<b>PROPOSED NEW ENTRANCE FOR FARM VEHICLES</b>		<b>Drainage Proposals &amp; Soakaway (Rev)</b>	
Drawing 6.2	SCALE 1:250 ON A3	Mr DW Roberts Bodynys Farm Ruthin LL15 1UL	
DATE 22nd February 2017

**WARD :** Llandyrnog  
**WARD MEMBER(S):** Cllr Merfyn Parry  
**APPLICATION NO:** 24/2017/0069/ PF  
**PROPOSAL:** Construction of new farm entrance  
**LOCATION:** Bod Ynys Rhewl Ruthin  
**APPLICANT:** Mr Dewi Roberts  
**CONSTRAINTS:** C2 Flood Zone  
**PUBLICITY UNDERTAKEN:** Site Notice - No  
Press Notice - No  
Neighbour letters - Yes

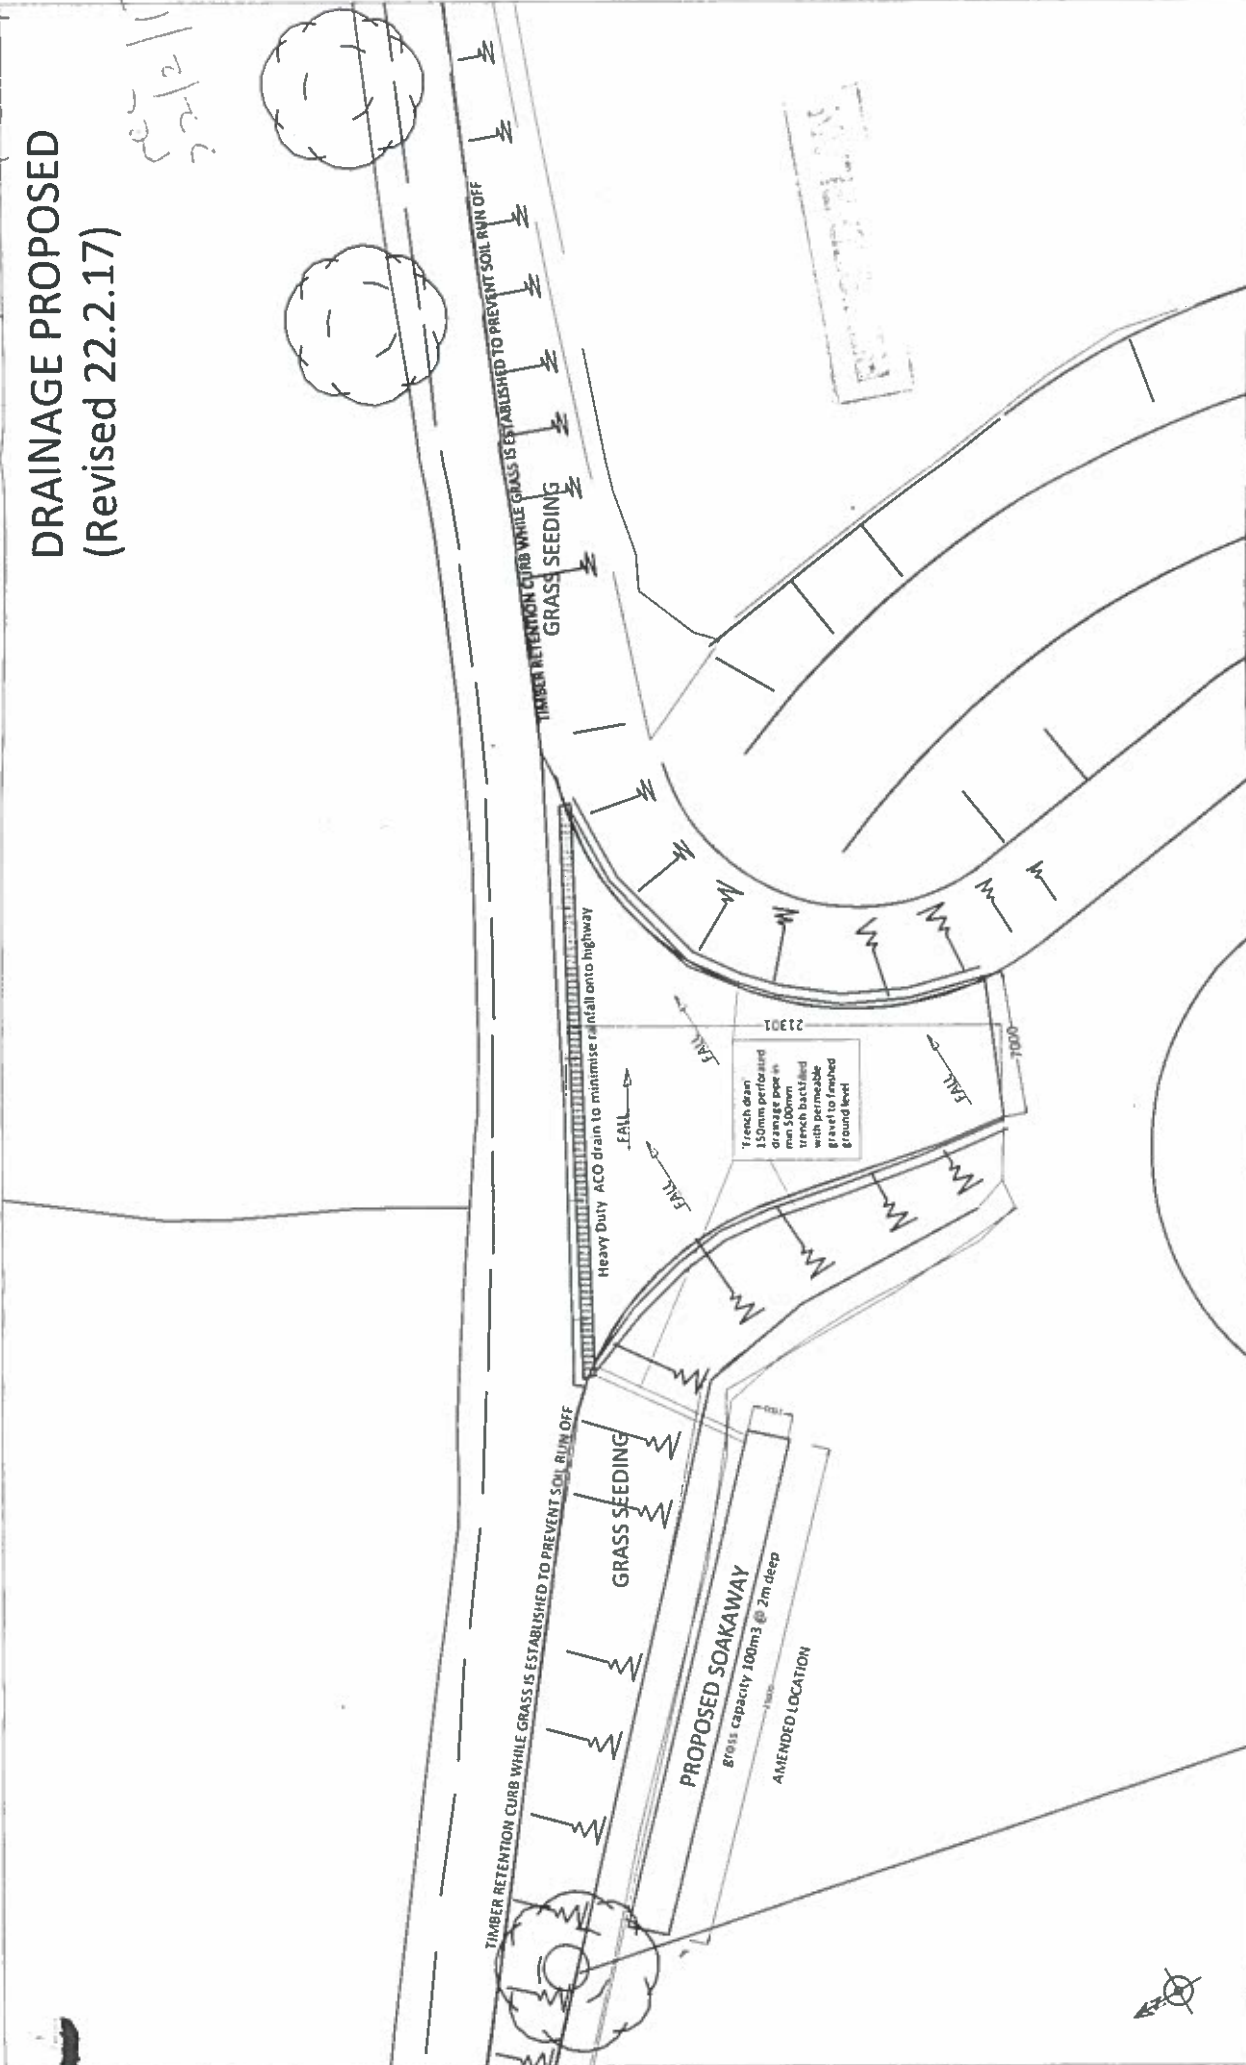
Pollution Control Officer. - With regards to private water supplies, Public Protection Officers initially raised concerns regarding the proximity of the proposed soakaway to the borehole which provides drinking water to the farm. Following the submission of a revised drainage plan which relocated the soakaway from than 50m from the borehole, Public Protection Officers confirmed they had no objection to the proposal from a private water supply perspective.

Public Protection Officers requested the soakaway is relocated to ensure a 50m buffer from the borehole which provides water to the farm and farmhouse. The drainage plan was amended to relocate the soakaway to the opposite (west) side of the access. Following the revised detail, Public Protection Officers confirmed they would have no objection to the proposal from a private water supply perspective.

- With regards to the crossfall of the access, it would appear that when the soakaway position and associated drainage was relocated to the opposite side of the entrance, the crossfall direction was not also amended. To this end, the crossfall of the access shall not be as shown on the drainage plan but shall drain towards the ACO drain.

- With regards to the soakaway, the Flood Risk Manager has confirmed he has no objection to the principle and location of the proposed soakaway, and has confirmed the soakaway is a sufficient distance from the slurry tank not to affect it, either permanently or during the excavation phase, providing the lateral dimensions of the soakaway are adhered to. However, taking into account the differences in ground levels between the road and the field in which the soakaway would be located, it is likely the soakaway would need to be deeper than the 2m proposed for it to be effective in collecting water from the Aco drain.

- (x) Site plan - vehicle turning (Drawing 4 Enter right) received 15 March 2017
3. Notwithstanding the approved details, the crossfall direction of the access and the capacity and depth of the soakaway shall not be as shown on the Drainage Proposals and Soakaway Plan (Drawing 6.2), but shall be as otherwise agreed in writing by the local planning authority prior to the development first being brought into use. The development shall then be implemented in accordance with the approved detail.
